Riley-Purgatory-Bluff Creek Watershed District
Board of Managers Workshop and Regular Meeting

Wednesday, July 12, 2017
5:30pm Board Workshop
7:00pm Regular Board Meeting
DISTRICT OFFICE
18681 Lake Drive East
Chanhassen

Riley-Purgatory-Bluff Creek Watershed District

June 7, 2017, Board of Managers Plan Workshop and Monthly Meeting

Figure 1. Sediment coring locations on Lotus Lake

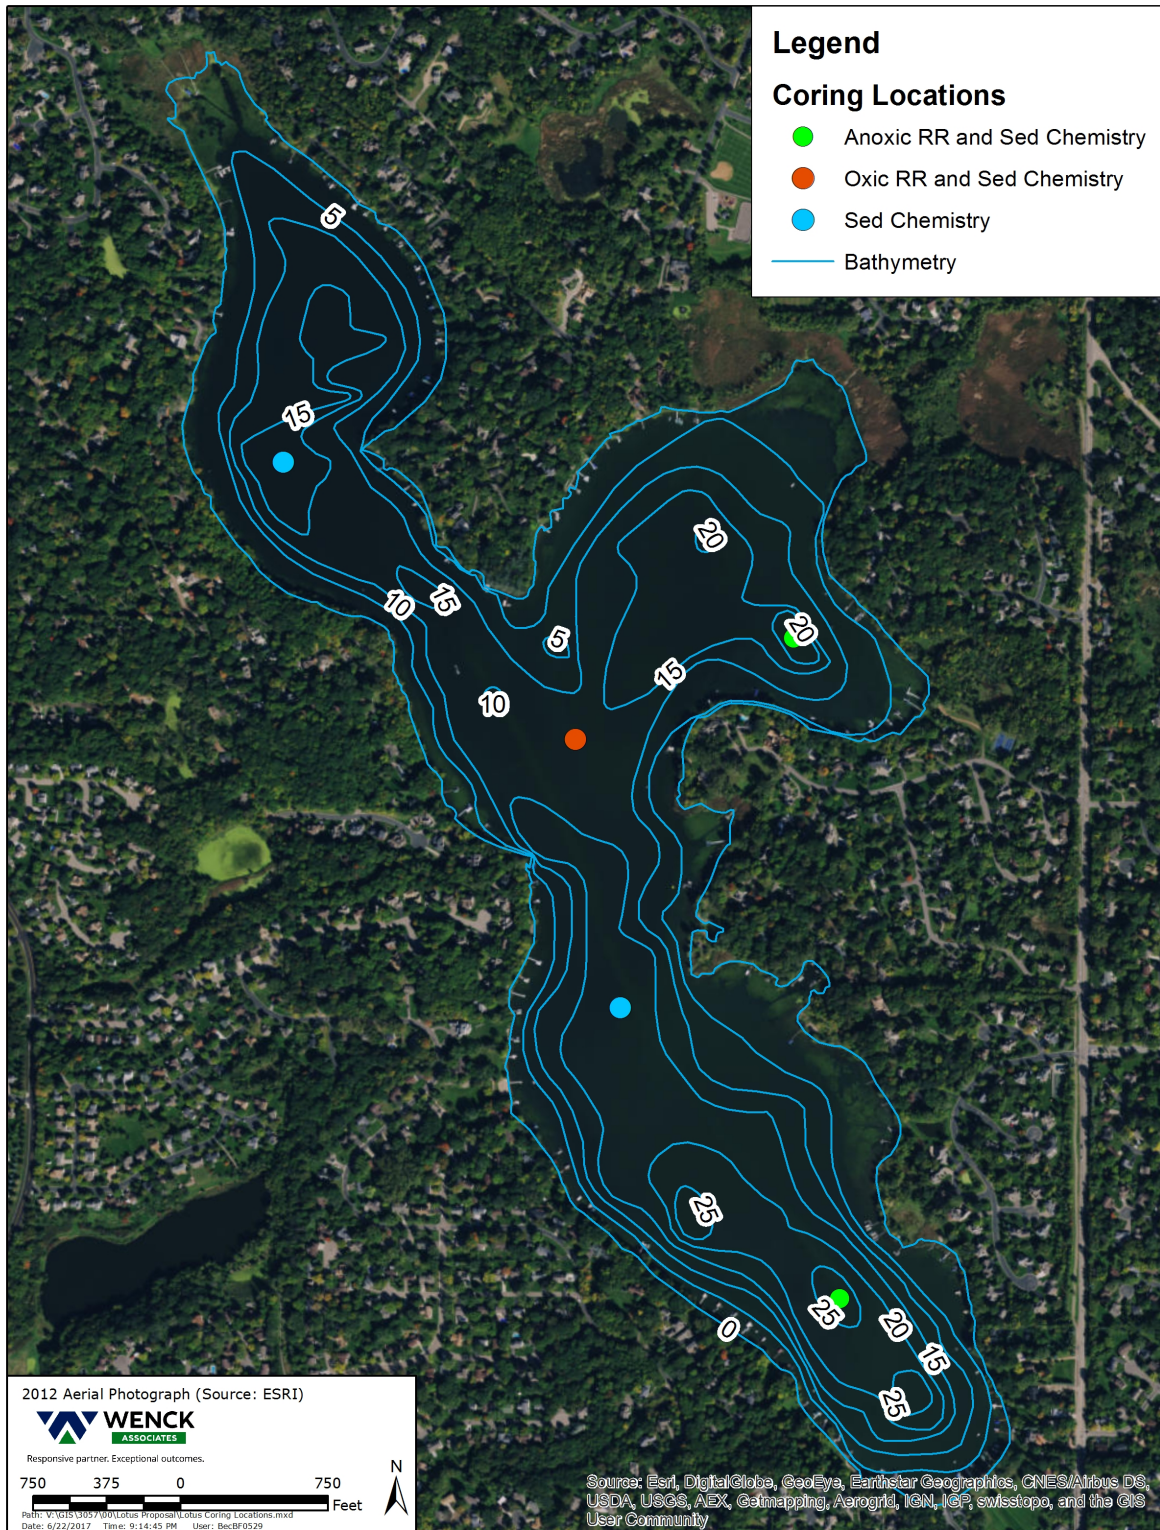
Wenck will collect intact sediment cores from Lotus Lake to estimate sediment chemistry vertical profiles for alum dosage cost estimates. Sediment cores will be collected from five locations on Lotus Lake (Figure 1). Cores will be transported to the University of Wisconsin-Stout for sediment chemistry analysis. Wenck is assuming that core collection will occur with at least one District staff person's assistance.

The intact sediment cores will be analyzed at UW-Stout. For Lotus Lake, all sediment cores will be sectioned every one cm from 0 to 6 cm, every two cm from 6 to 10 cm, and every 2.5 cm from 10 to 25 cm to determine vertical profiles of phosphorous fractionation, organic matter content, bulk density, and total metal concentration. Additionally, sediment cores from two locations will be incubated to measure anoxic release rates (Anoxic RR) in deeper portions of the lake (Figure 1). Sediment cores for a shallower area of the lake will be incubated for release rates under oxic conditions (Oxic RR) (Figure 1).

Figure 1. Cross-Section of existing shoreline conditions showing stepped retaining wall, vertical face below OHW, and gravel along the shoreline.

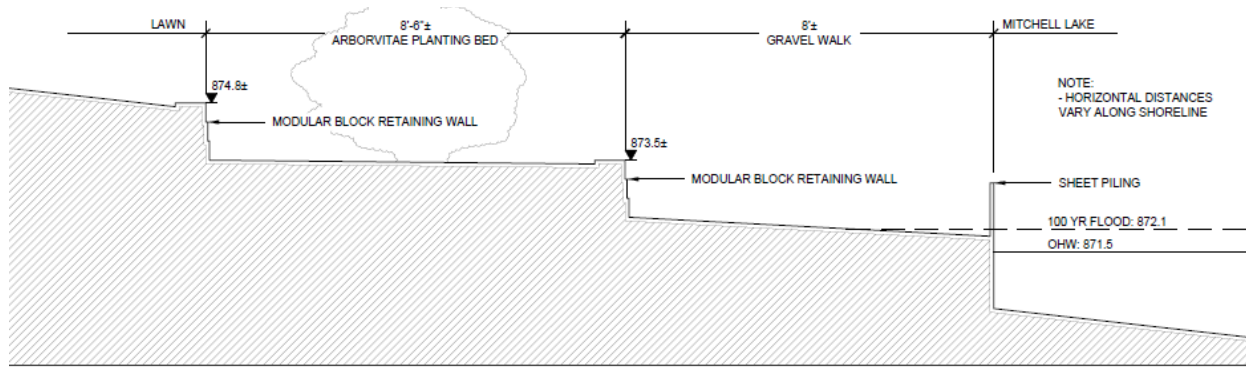
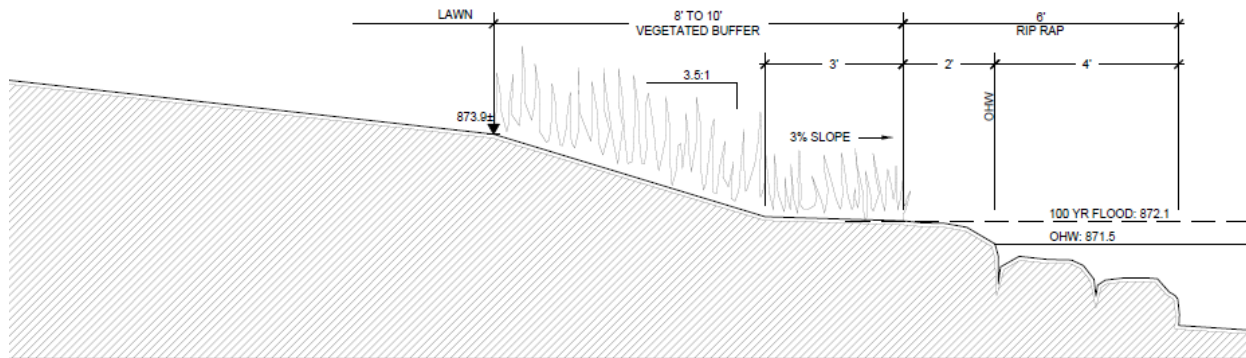
The plans prepared by Natural Environments Corporation show removal of existing hardcover including an existing seawall and concrete boat launch, location of sediment control best management practices both prior to removals and after removals, location of riprap, location of coir logs, location of buffer plantings, and location of sand blanket. As to the 'need' criterion in 3.1 of the rule, no erosion or threat of erosion is present, nor is the existing shoreline degraded, so there is no need to address existing or threatened risks. Further analysis of the project under this criterion is provided under the Rule K exception analysis below. Paragraph 3.2 sequencing is addressed under the exception framework below as well.

The design is consistent with Rule F, §3.3. Only native plants are being used for the stabilization and the riprap is sized appropriately for the conditions. The riprap will be hand-placed and extend only to the OHW and extend no more than six (6) feet waterward. The design calls for a transitional crushed rock layer with geotextile and will be free of foreign materials such as clay or debris.
